PIC18FXX2 Rev. C0 Silicon/Data Sheet Errata

The PIC18FXX2 Rev. C0 parts you have received conform functionally to the Device Data Sheet (DS39564B), except for the anomalies described below.

Clarifications/Corrections to the Data Sheet:

FIGURE 1: PINOUT DIAGRAM FOR PIC18F442/452, 44-PIN QFN PACKAGE

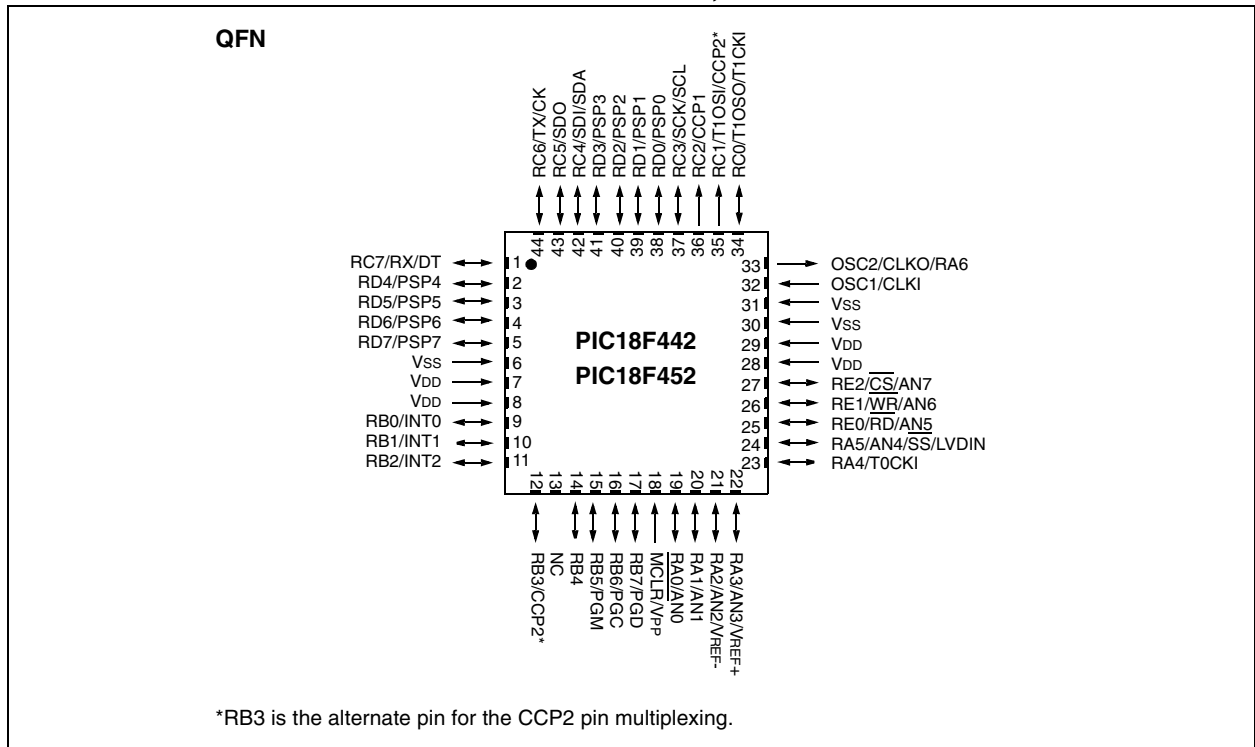
PIC18F442 and PICF452 devices are now offered in 44-pin, near chip scale micro lead frame packages (commonly known as “QFN”). This packaging type has been added to the product line since the latest revision of the Device Data Sheet.

1. The “Pin Diagrams” on pages 2-3 of the Data Sheet are amended with the addition of the 44-pin QFN pinout, shown in Figure 1.
2. Table 1-3 of **Section 1.0 “Device Overview”** is replaced with an updated version which adds a column for QFN pin assignments. A row is also added for previously unlisted NC pins. All new information is indicated in **bold**.

FIGURE 2: PACKAGE MARKING TEMPLATE FOR PIC18F442/452, 44-PIN QFN

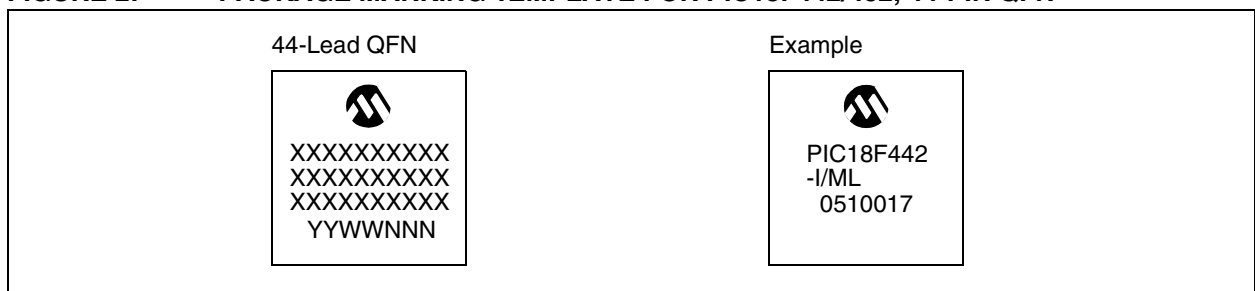
3. **Section 24.1 “Package Marking Information”** is amended to include a marking template and example for 44-pin QFN devices. These are shown in Figure 2.

FIGURE 3: 44-PIN QFN PACKAGE

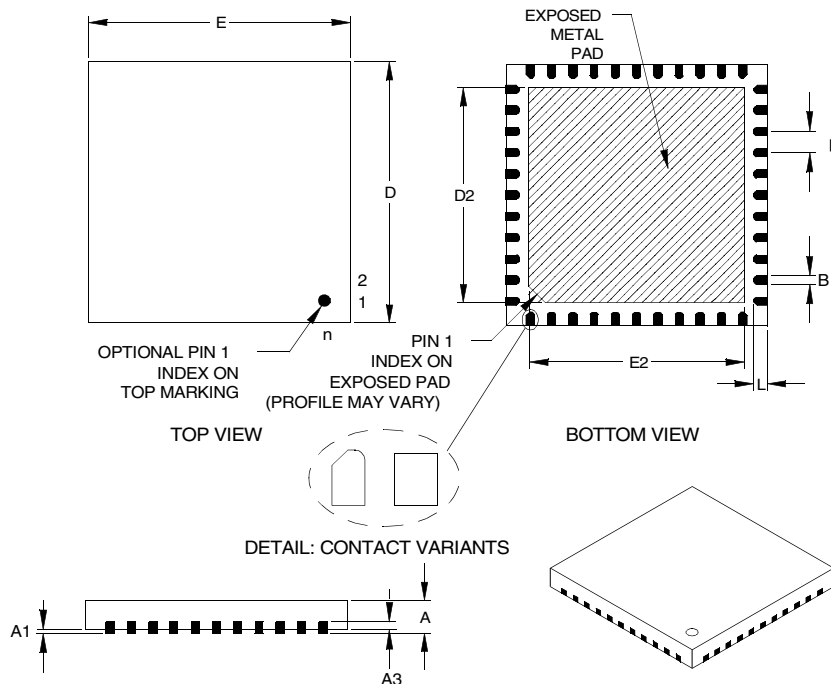
4. **Section 24.2 “Package Details”** is amended to include the mechanical drawing of the 44-pin QFN package, shown in Figure 3.
5. In the **“PIC18FXX2 Product Identification System”** (page 329), the “Package” options are amended to include the new line item:
ML = QFN
